Access Compliance Report Public Rights-of-Way (Curb Ramps)

Main Street: CABARET_CT Cross Street: FAIRHAVEN_AVE Location: SW

ADA ID: RPRK220222205104 Ramp Type: Type 4 - Parallel Initial Pass/Fail: Fail Overall Compliance: No Severity Score: 16

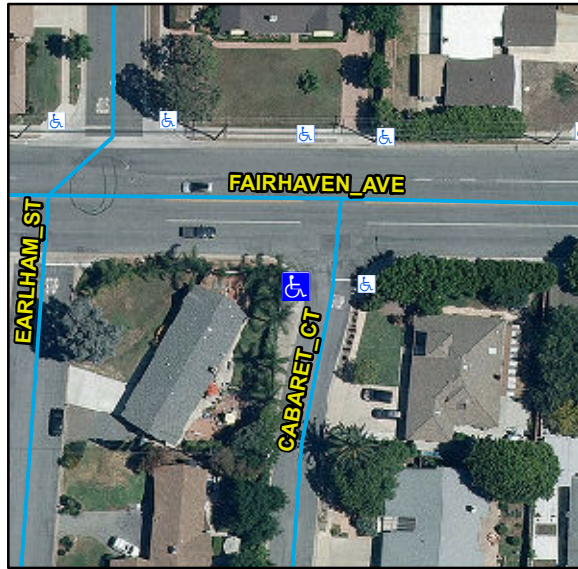
R304.5.3, R304.3.2, STD 1115

Remove & Replace Curb Ramp With Two New Directional Ramps or Equivalent.
